Southern Nuclear Operating Company
Vogtle Electric Generating Plant Units 3 and 4
Request for License Amendment: Containment Internal Structural Module
Shear Stud Size and Spacing (LAR 12-001)

Containment Internal Structural Module Shear Stud Size and Spacing

Figure 3.8.3-8 (Sheet 1 of 3)

[Structural Modules – Typical Design Details]*

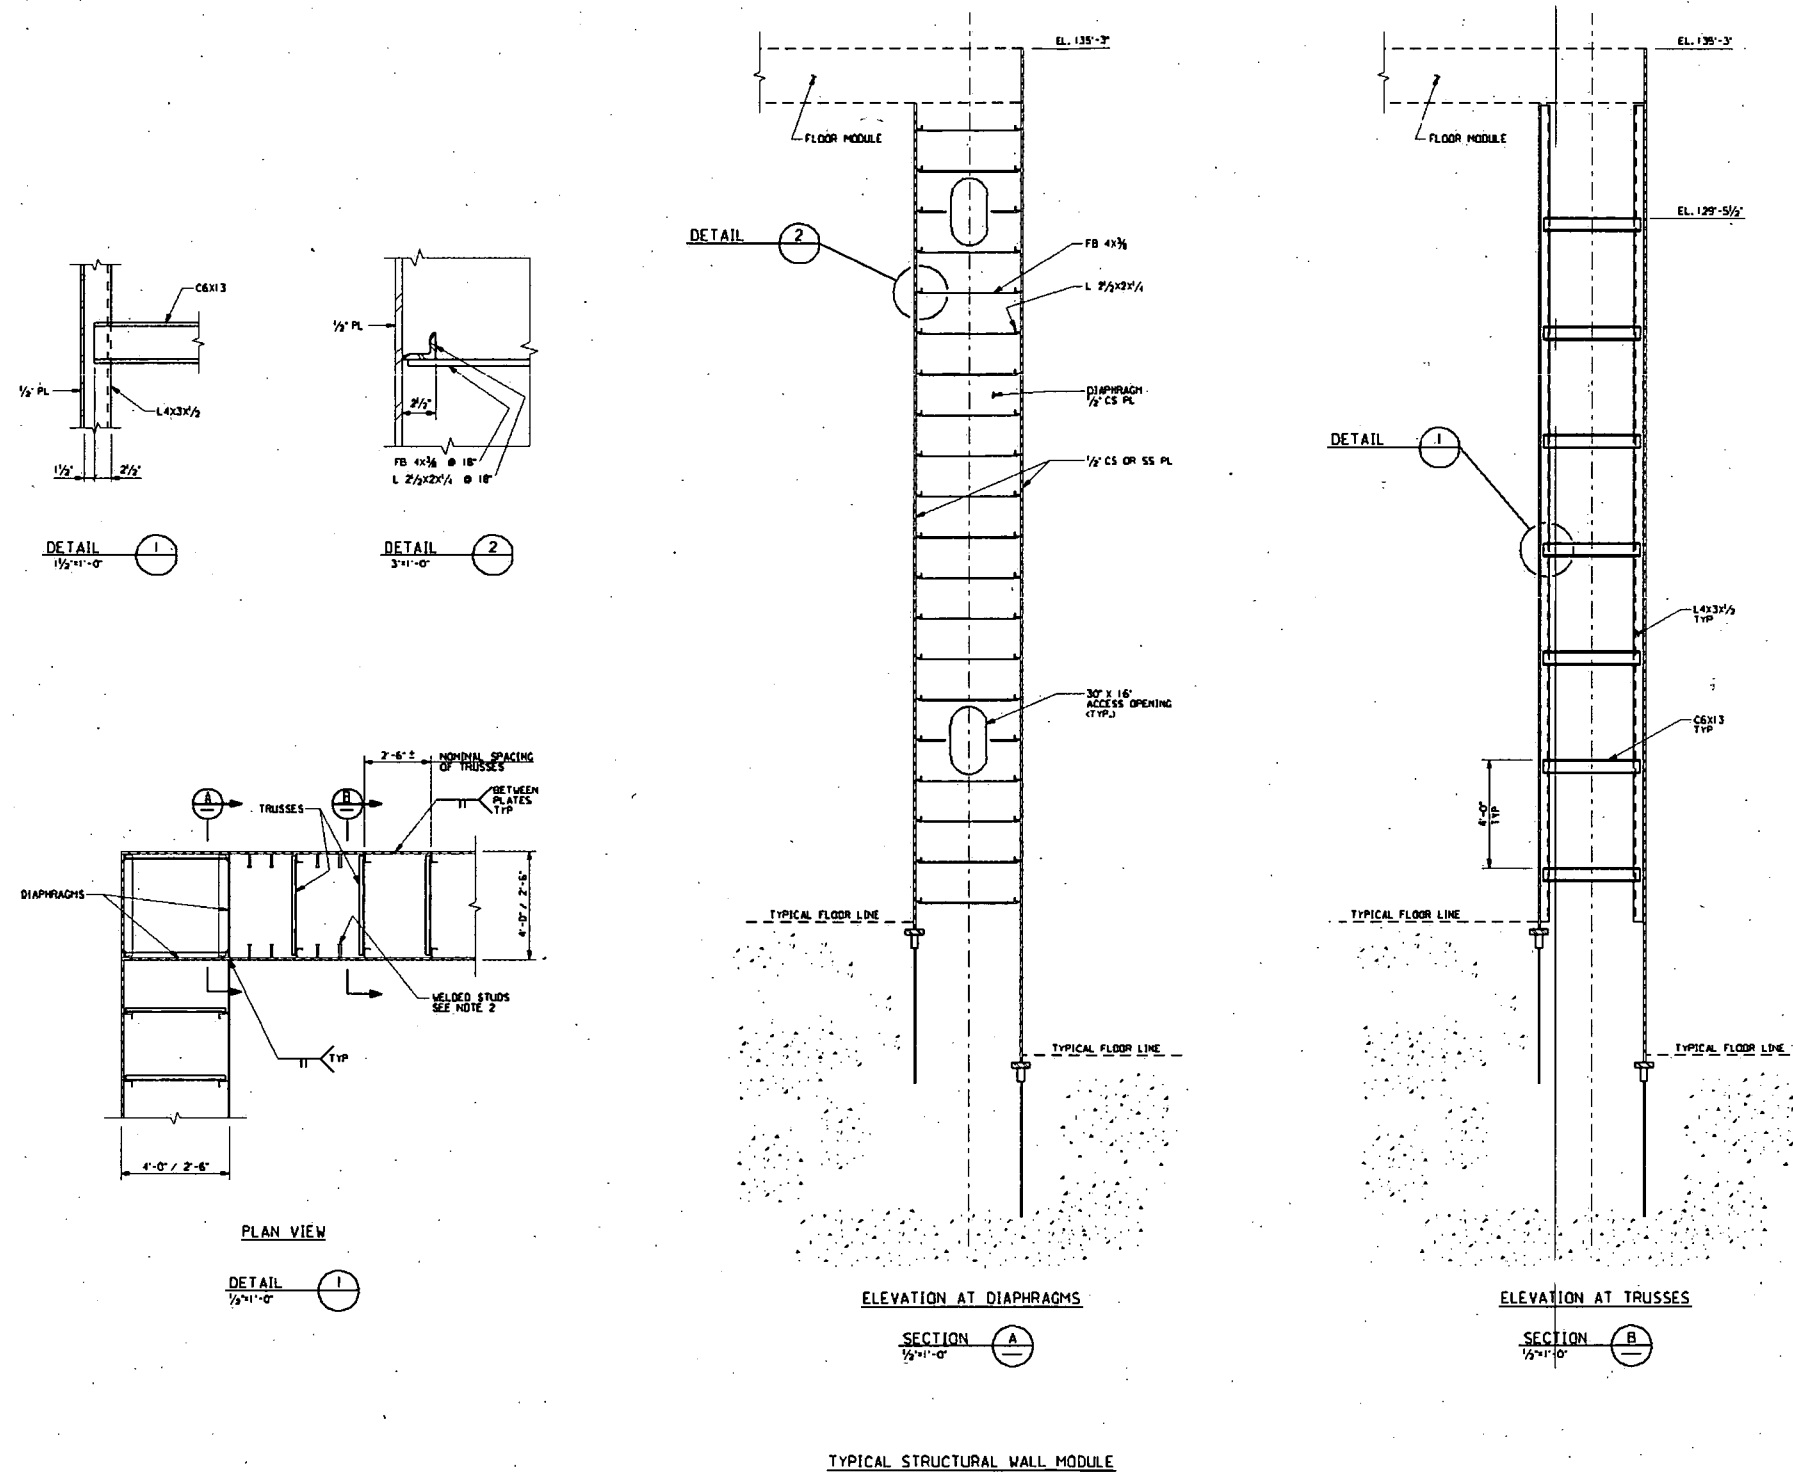
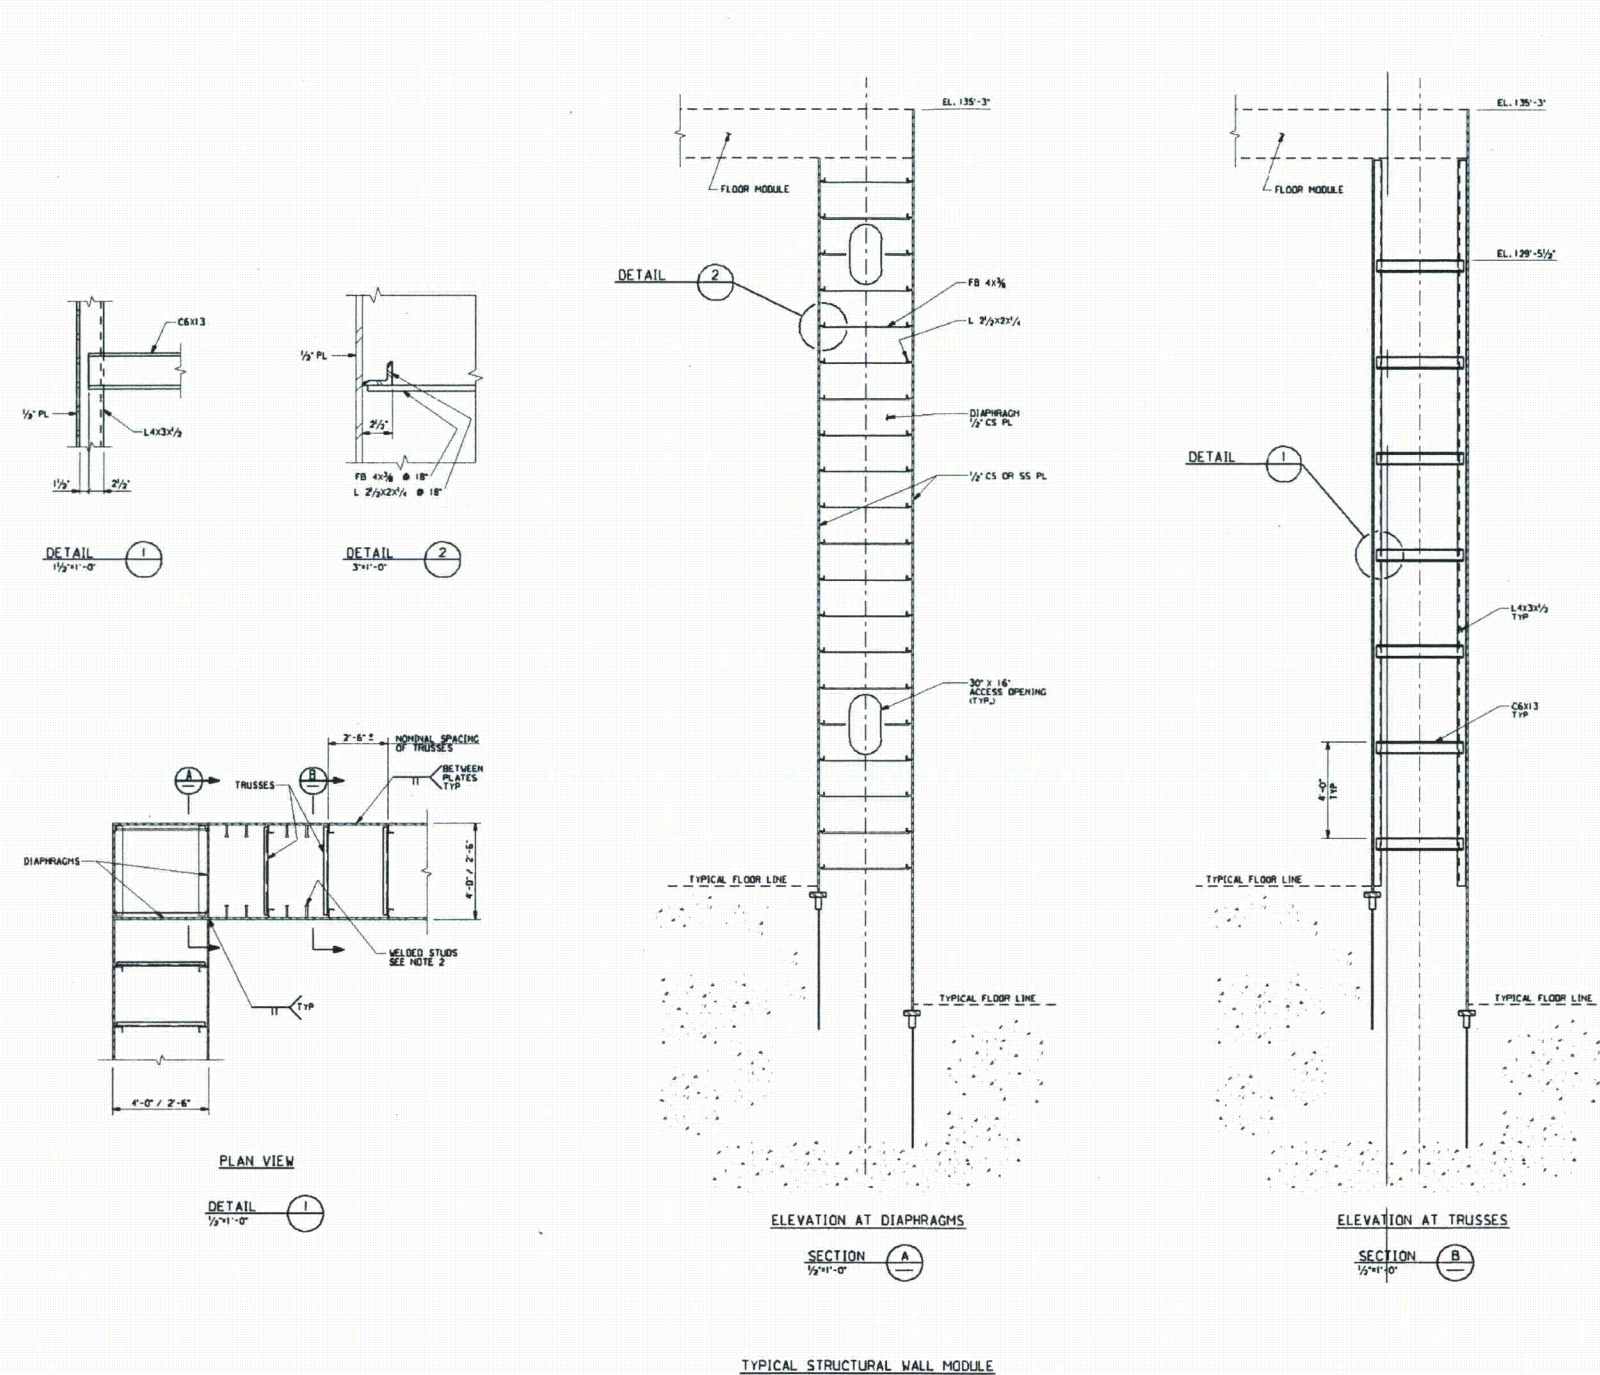
Plant-specific DCD Figure 3.8.3-8, Sheet 1, Note 2 includes information on the size and spacing of the shear studs in the structural modules. This information needs to be updated to reflect the current design basis. The existing Note 2 shows welded studs for stainless steel plate with 3/4-inch diameter and a spacing of 10 inches horizontal and 8 inches vertical. The design basis calculations show the size and spacing of the studs is 5/8-inch diameter with a 6-inch horizontal by 6-inch vertical spacing. For carbon steel plate, Note 2 shows welded studs with 3/4-inch diameter and spacing of 9.6 inches vertical and 10 inches horizontal. The design basis size and spacing of the studs for carbon steel plate is 3/4-inch diameter with a 10-inch by 10-inch spacing. The change is required to make Note 2 consistent with the design basis. The text of the note is changed to clarify that spacing may be changed to satisfy codes and standards.

Note 2 on Sheet 1 of plant-specific DCD Figure 3.8.3-8 will be revised as shown below.

2. WELDED STUDS SHALL BE SPACED AS FOLLOWS,
UNLESS ~~NOTED~~ OTHERWISE REQUIRED BY THE
SPECIFIC CODES AND STANDARDS INVOKED:

$\frac{3}{4}$ " \varnothing x 6" @ ~~9.6"~~ 10" VERTICAL FOR CS

$\frac{3}{4}$ " \varnothing x 6" @ 10" HORIZONTAL FOR CS

~~$\frac{3}{4}$ " $\frac{5}{8}$ " \varnothing x 6" @ 8" 6"~~ VERTICAL FOR SS

~~$\frac{3}{4}$ " $\frac{5}{8}$ " \varnothing x 6" @ 10" 6"~~ HORIZONTAL FOR SS

- NOTES:**
1. ALL WORK SHOWN ON THIS DRAWING IS SEISMIC CATEGORY 1.
 2. WELDED STUDS SHALL BE SPACED AS FOLLOWS, UNLESS OTHERWISE REQUIRED BY THE SPECIFIC CODES AND STANDARDS INVOKED:
 1/2" x 6" @ 18" VERTICAL FOR CS
 1/2" x 6" @ 18" HORIZONTAL FOR CS
 1/2" x 6" @ 18" VERTICAL FOR SS
 1/2" x 6" @ 18" HORIZONTAL FOR SS
 3. THE TYPICAL DETAILS SHOWN REPRESENT THE FUNDAMENTAL APPROACH FOR THE COMPOSITE WALL MODULES. THE FINAL DESIGN DETAILS MAY DIFFER FROM THOSE SHOWN FOR THE FOLLOWING REASONS:
 • ACCESSIBILITY FOR INSPECTION DURING FABRICATION AND CONSTRUCTION
 • LESSONS LEARNED FROM IMPLEMENTATION OF THE DESIGN
 • EASE OF FABRICATION AND CONSTRUCTION
 • RESOLUTION OF CONSTRUCTABILITY ISSUES AND SEQUENCES
 • VARIATION IN MODULE SIZE AND CONFIGURATION
 CHANGES MADE DURING DETAILED DESIGN ARE IN ACCORDANCE WITH THE SPECIFIC CODES AND STANDARDS INVOKED.
